## Facility Conditions Assessment Questions & Answers

**MEYDENBAUER  
CENTER**

A2.4.1

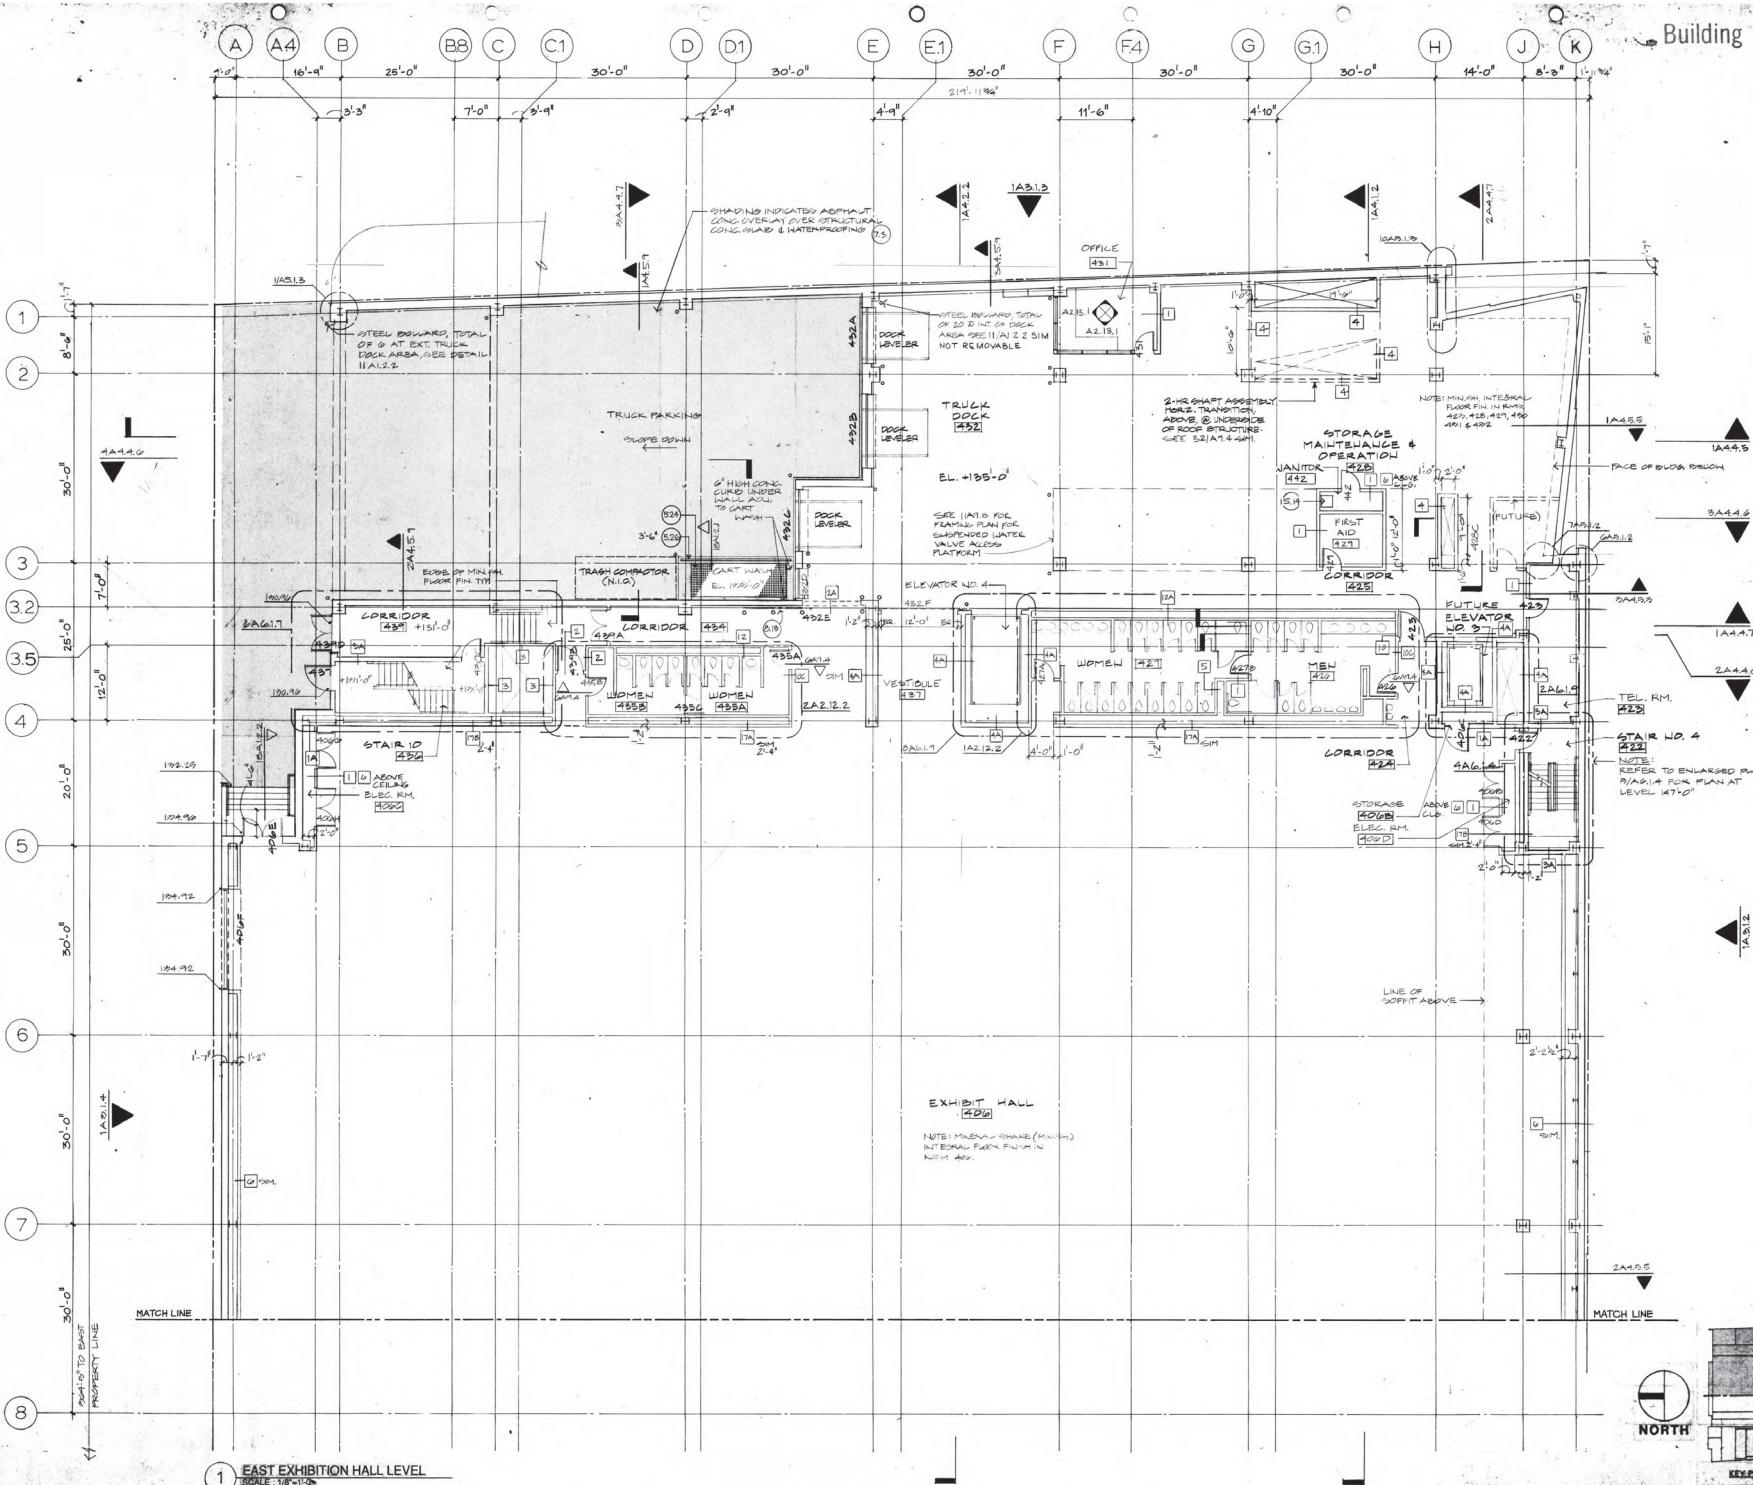
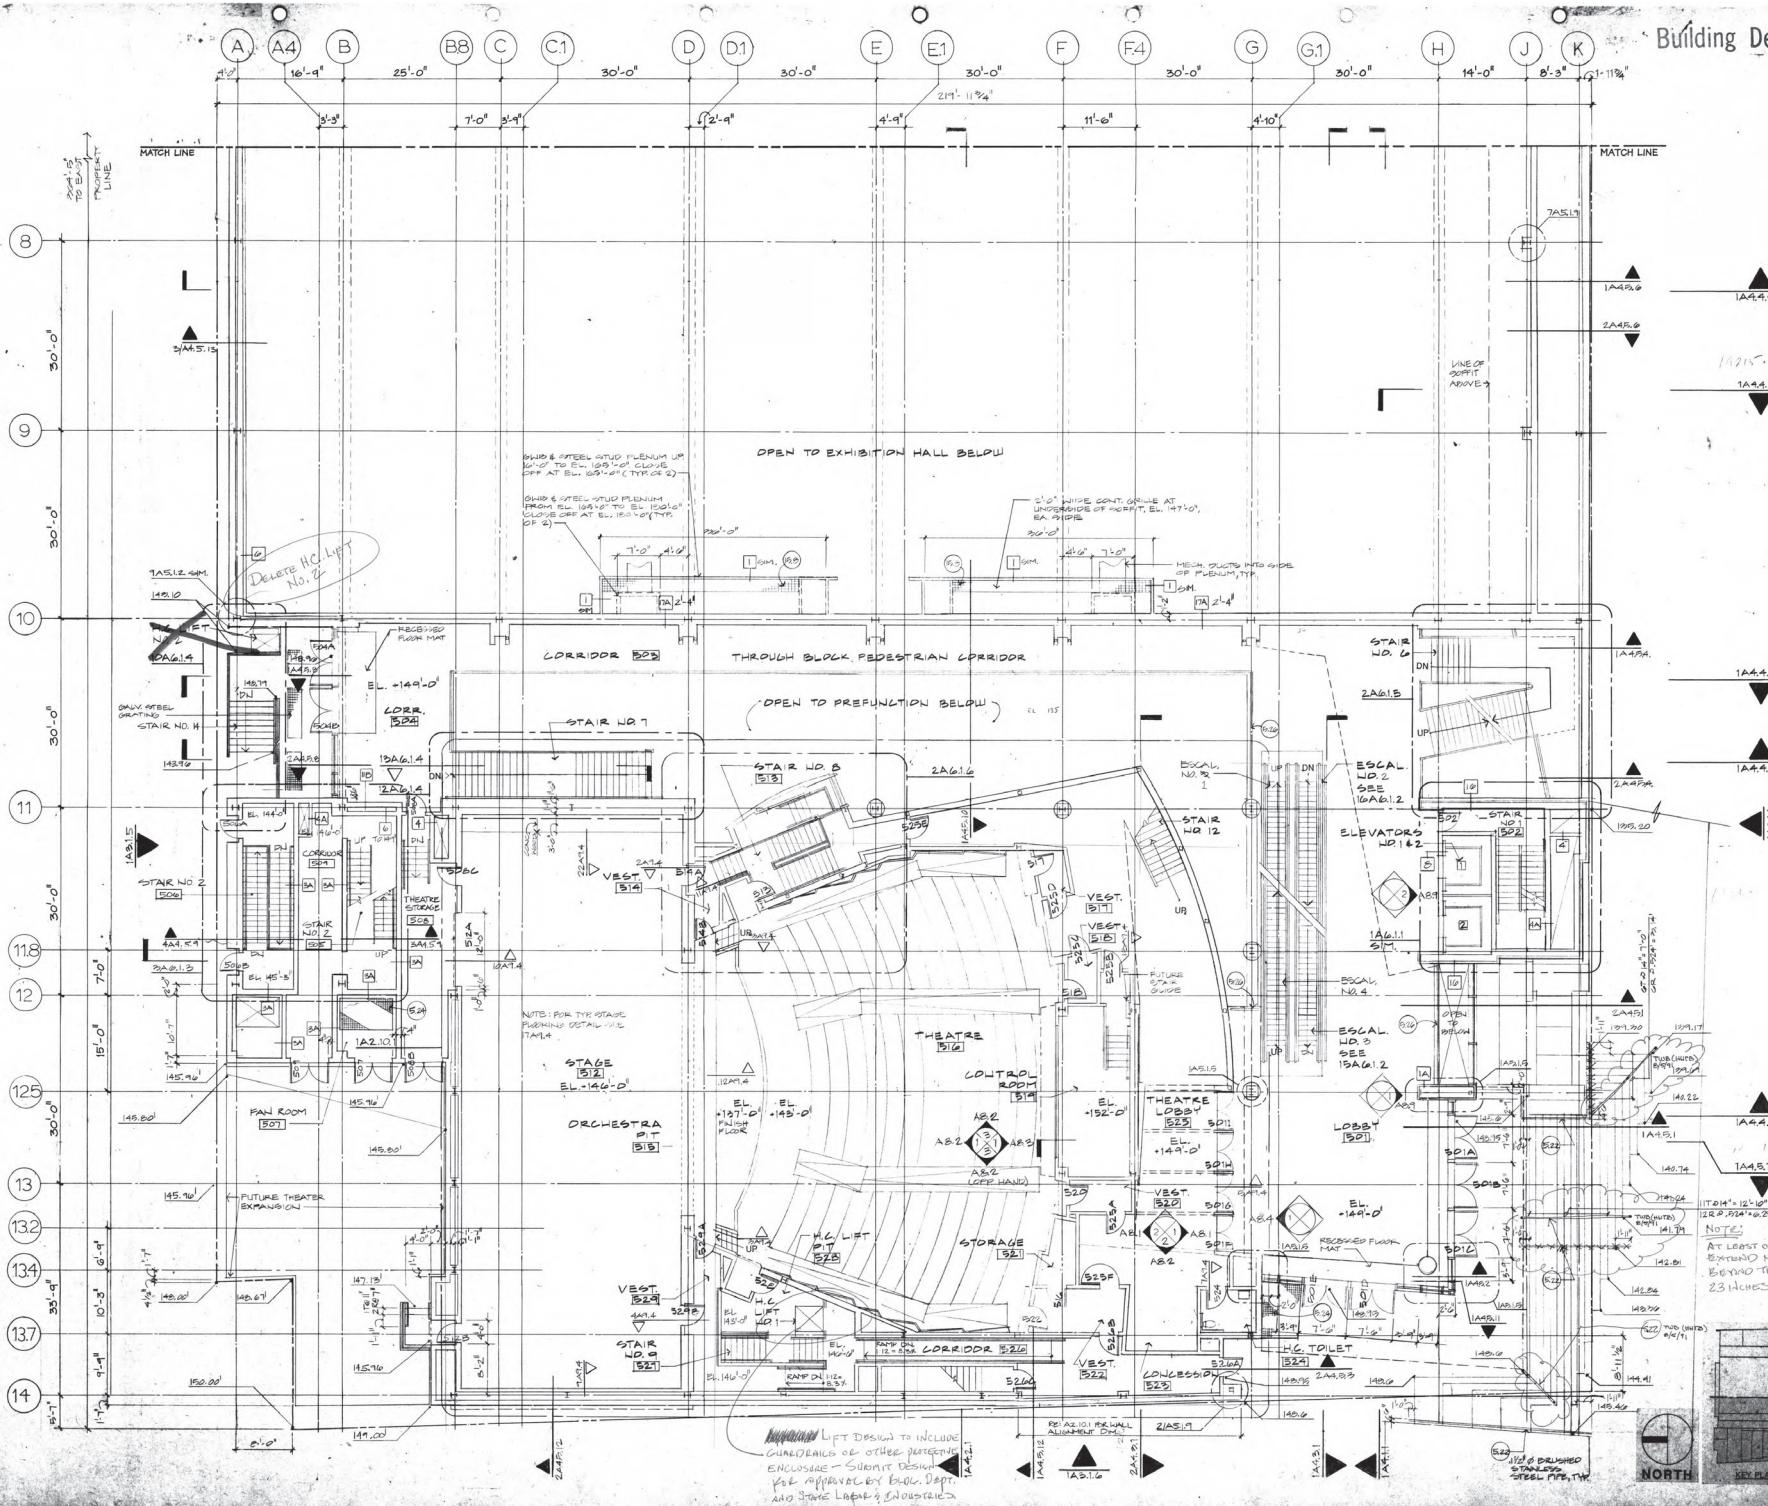
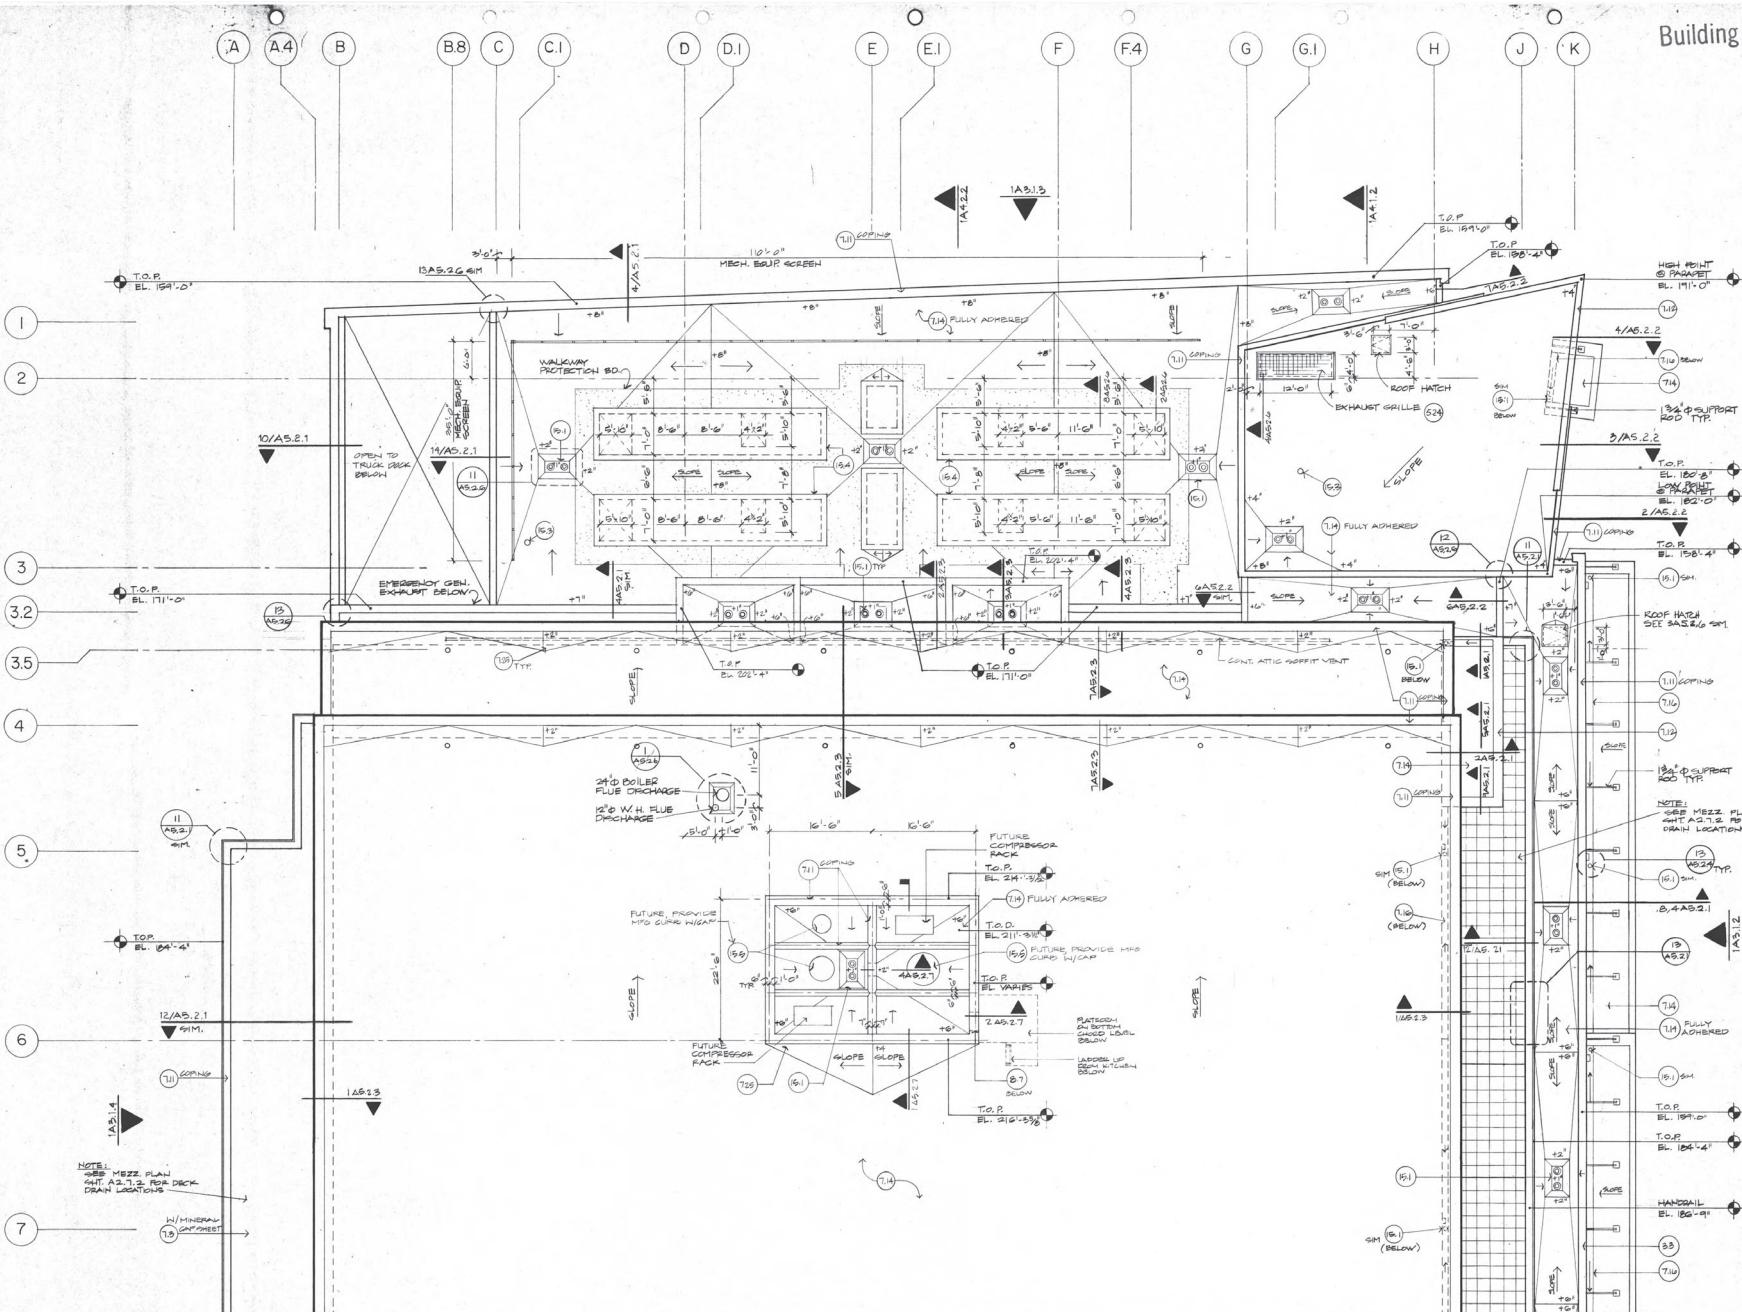
**Question:** *Would it be possible to obtain some sort of floor plans of the facility to better understand the overall layout.*

**Answer:** Included in this packet are some of the original as-builts by floor to give you a sense of the layout.
